Reply to PHENIX Review of Muon Trigger Electronics
MuTr FEE upgrade group
April 1, 2008

We would like to thank the review committee for high evaluation of our work in the design and testing of prototype electronics in PHENIX. In the following, we provide additional information regarding to remarks/suggestions raised by the review committee. Remarks/suggestions are shown in blue, while our reply is typed in black.

Figure 1 MuTrg-ADTX prototype board

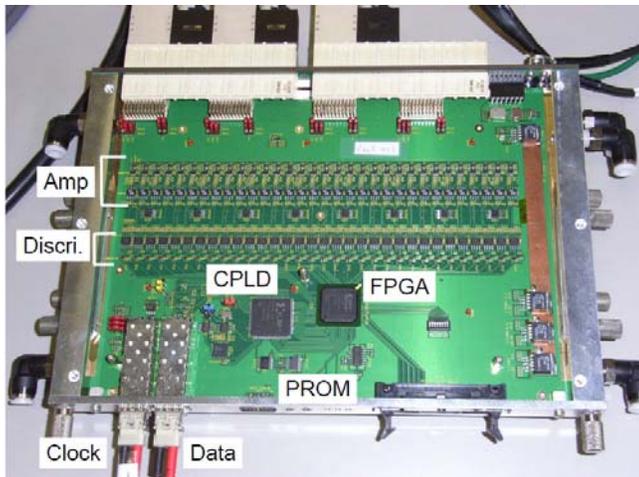
The separate AD and TX boards have been well and extensively tested, including tests in the north muon magnet last summer, however the plan presented to combine them into a single board has many advantages including:

- smaller footprint in the magnet and in front of station 1
- fewer cables and connections which should increase reliability
- lower cost, including fewer LV cables running into magnet and fewer types of boards to build
- likely better grounding and lower noise

It would however be prudent to verify these advantages before embarking on a rather large production run of boards. It should be noted that at the time of this review, the combined AD/TX board prototype was in the final stages of production, so test results, even from bench tests or on the test chamber, were not available. Noise from the digital and analog grounds on the board, for example, are highly sensitive to the details of the board layout, and so thorough tests on the bench and in a realistic noise environment are critical to success.

Therefore, we suggest that a full test of two of these new AD/TX boards in the north magnet during run8, with emphasis on verifying the noise performance of the new AD/TX board, be carried out, despite it possibly necessitating rearrangement of the production schedule.

We fully agree with several advantages of combined board described above. After necessary revision of design, a prototype for the AD+TX combined board (MuTRG-ADTX) has been produced (Fig. 1). New features are (1) single 6U-size board with all functions of two boards (AD and TX), (2) separate GNDs for analog part and digital part, (3) a CPLD for slow control, and (4) thinner chassis by optimizing the backplane design.

Figure 4 Existing FEE and ADTX chassis with newly developed mounting scheme

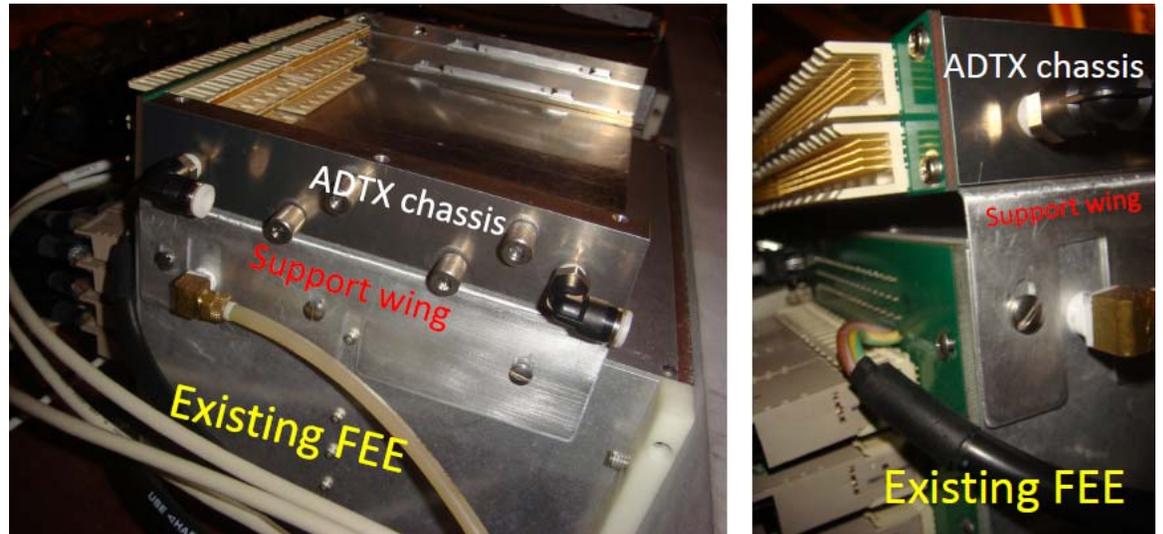
- The scheme to mount chassis at station 2 to the existing FEE chassis needs to be engineered in a more minimal way using existing holes but with strength enough to hold "upside-down" chassis on the top. Provision for several large ground connections between the two chassis should be provided.

We have developed more concrete mounting structure under a consultant of Walter and Jimmy. A new mounting structure was tested in the station 2, octant 7 as shown in Fig. 3 below. A bottom plate of the chassis was replaced with aluminum plate with extended support wings on both sides.

The wings hold the chassis by using existing six unused screw holes (three each) on both sides of FEE chassis. This mounting scheme ensures the tight mechanical and electrical connection to the existing FEE. The chassis will be elevated about 5/16 inch to allow the ADTX board in the bottom slot to be installed/uninstalled without interfering with the spider frame.

Figure 5 heat profile without cooling water

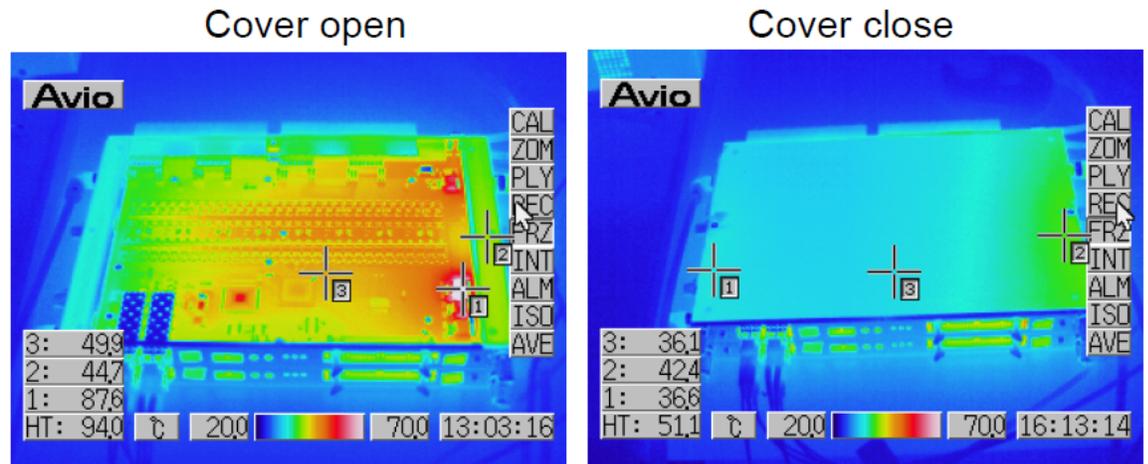
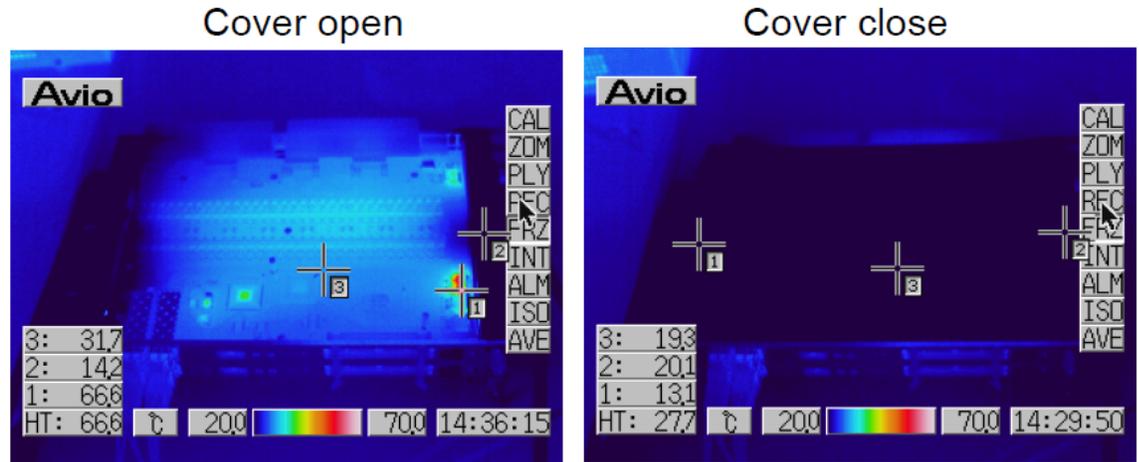
- Considerable power may be dissipated in the regulators on the board if supplied with a single voltage. The board should be imaged with an IR camera to determine if the power dissipation at the regulators is prohibitive; this could suggest that bringing in multiple voltages could be desirable.

It is true that power dissipation at the regulators is not small. The heat profile of the MuTRG-ADTX board was measured with an IR camera. Figure 4 and 5 shows the heat profile without and with cooling water. The numbers in the left bottom corner is the temperature in degree Celsius.

Indeed, temperature at the regulators is as high as 94 degree Celsius without cooling water. With water cooling from the chassis, the temperature goes down to about 67 degree Celsius. This concludes that the existing water cooling system has enough cooling power to keep the board temperature within normal operation temperature for the electronic parts on the board.

Figure 7 Transmission efficiency from MuTRG-ADTX to a receiver board as a function of clock frequency.

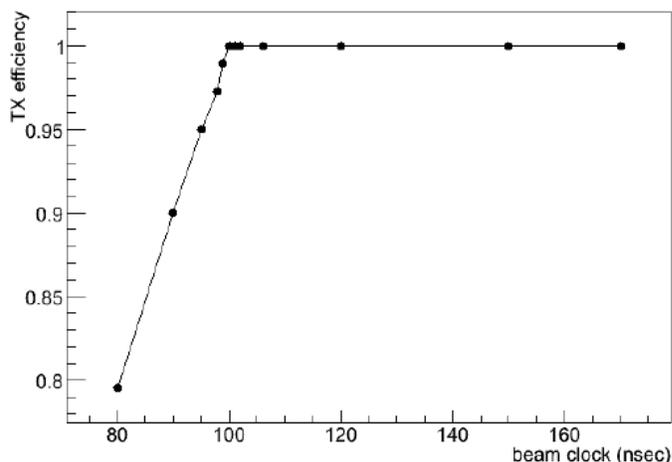
- The clock frequency should be varied around the nominal 9.4 MHz to make sure the boards operate correctly for clock frequencies at least 5% different from the nominal clock frequency.

A data transmission from MuTRG-ADTX board was tested with various beam clock frequency. Patterns of pulse were fed to the inputs for the MuTRG-ADTX, the board transmitted discriminated data to a receiver board (former TX board with minor modification). Transmission efficiency was evaluated by the ratio of number of received events divided by total number of inputs. The transmission efficiency at various beam clock frequency is shown in Fig. 6. From Fig.6, we conclude no inefficiency is introduced when the clock frequency is changed by +/-5% from the nominal frequency (106ns).
